Change Requested dated 11/20/72  
License No. DPR-22

Your letter dated November 20, 1972, submitted proposed changes to Appendix A of the Technical Specifications of Provisional Operating License No. DPR-22 for the Monticello Nuclear Generating Plant. The request for change included proposed revisions to the reporting requirements section of the Technical Specifications.

Change No. 4 to Technical Specifications  
Provisional Operating License No. DPR-22  
Northern States Power Company  
Docket No. 50-263

FIGURE 6.1.1

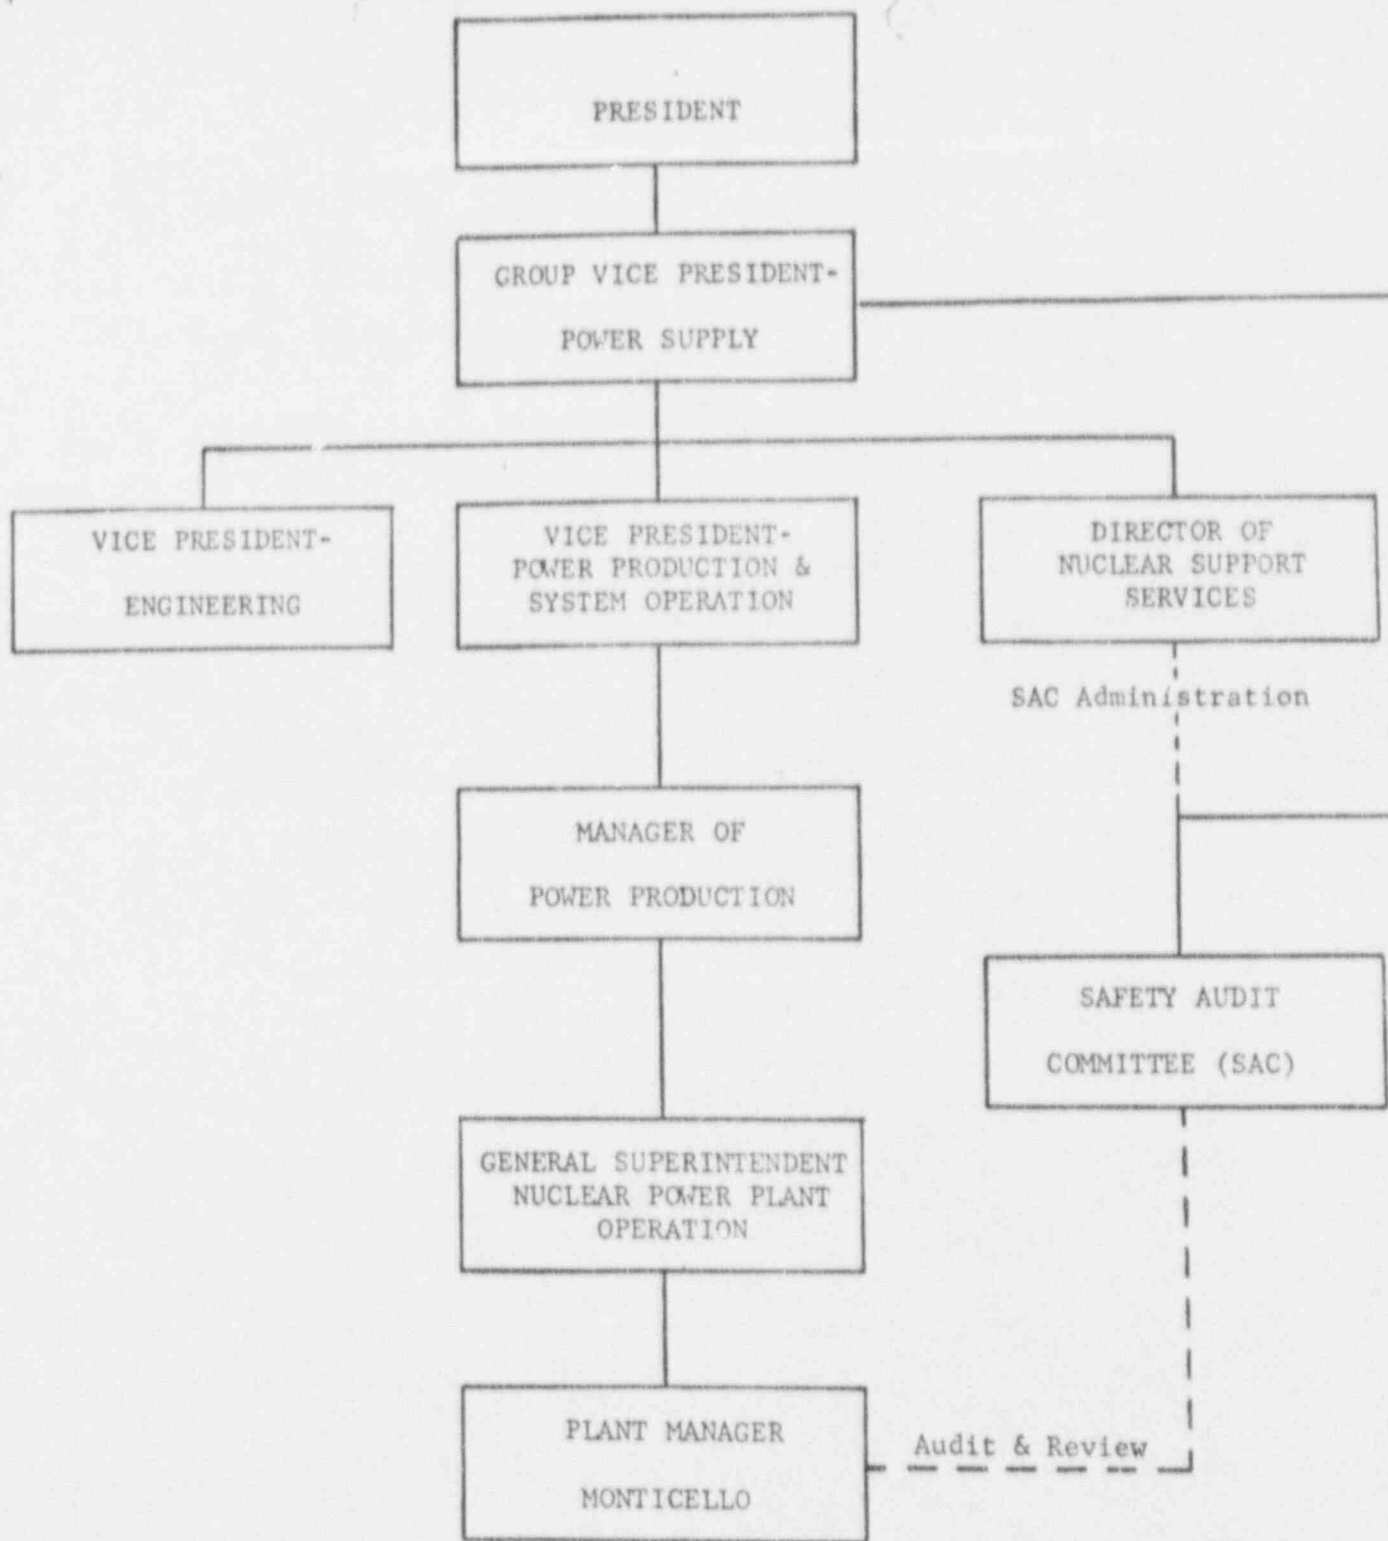
Change Specification 6.0 Administrative Controls in its entirety to read:

- B. The Northern States Power corporate organizational structure relating to the operation of this plant is shown in Figure 6.1.1.
- C. The minimum functional organization for operation of the plant shall be as shown in Figure 6.1.2. The minimum shift complement for special plant conditions shall be as follows:

FIGURE 6.1.2

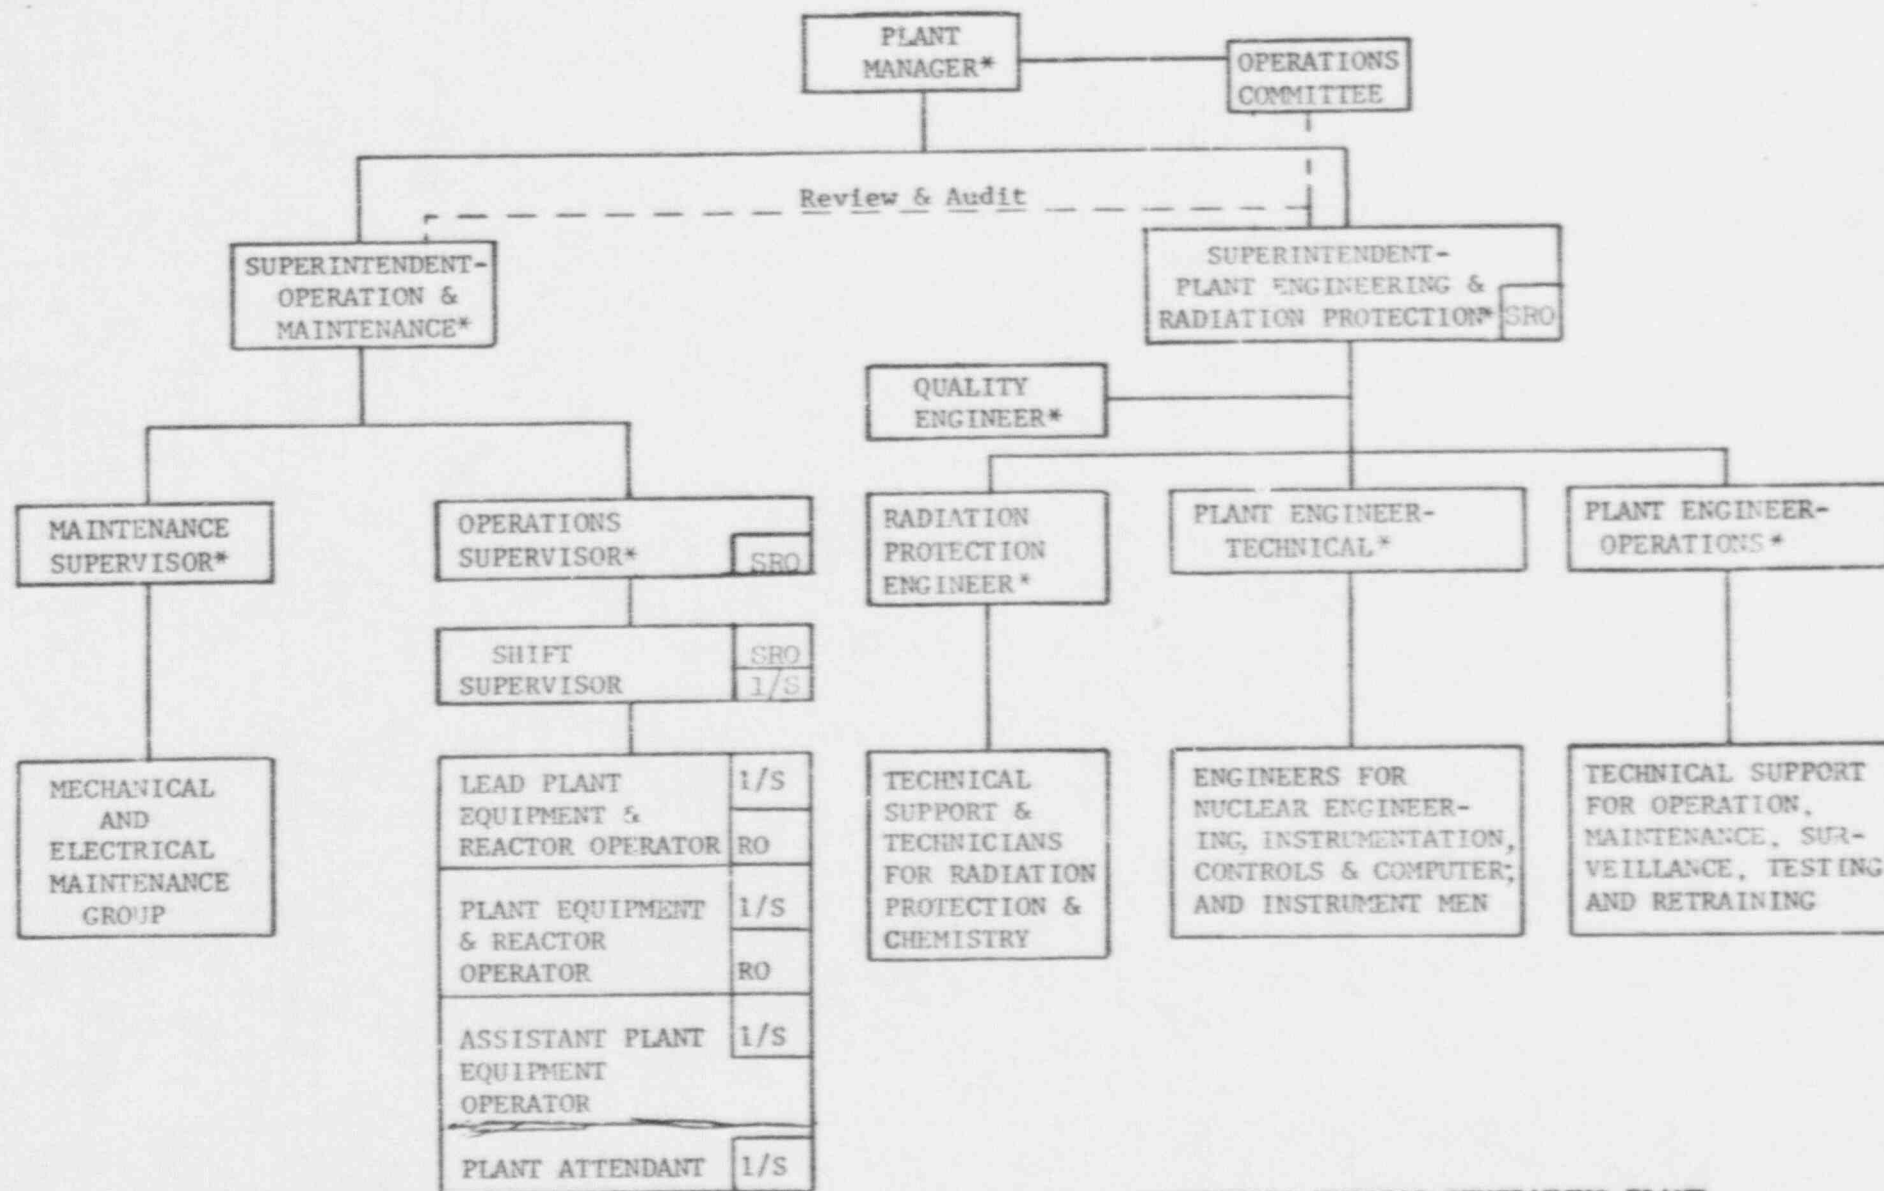
- (1) Changes in plant design,
- (2) performance characteristics (e.g., equipment and fuel performance),
- (3) changes in procedures which were necessitated by (1) and (2) or which otherwise were required to improve the safety of plant operations,
- (4) results of surveillance tests and inspections required by these Technical Specifications,
- (5) the results of any periodic containment leak rate tests performed during the reporting period,
- (6) a brief summary of those changes, tests, and experiments requiring authorization from the Commission pursuant to 10 CFR 50.59(a), and
- (7) any changes in the plant operating organization which involve positions which are designated as key supervisory personnel on Figure 6.1.2.
